Service Bulletin

Indigo and Indigo NXT Replacement Water Level Probe

REPLACEMENT WATER LEVEL PROBE AND WIRING HARNESS

Replacement Water Level Probe With Harness 000016053

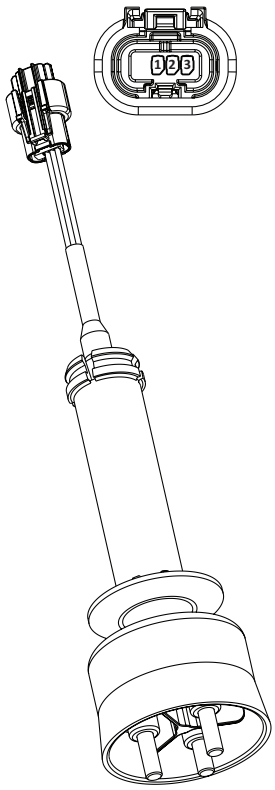
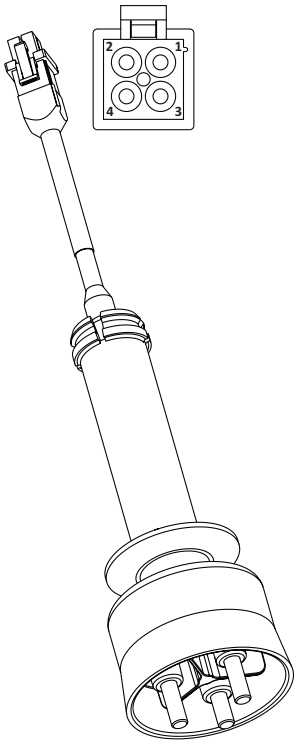
A replacement water level probe/harness assembly is available that allows universal water level probe replacement for all Indigo and Indigo NXT models.

- The replacement water level probe and wiring harness are easily identifiable as the electrical connector is oval rather than square.
- The wire harness is included with water level probe 000016053.
- The wire harness will need to be replaced with the water level probe and routed to the control box.

> **⚠ Caution**
>
> Do not cut and splice the connector onto the old/existing wire harness as erratic operation will result.

No Longer Available Water Level Probe 000007052 56” Wiring Harness 000007724 42” Wiring Harness 000007099
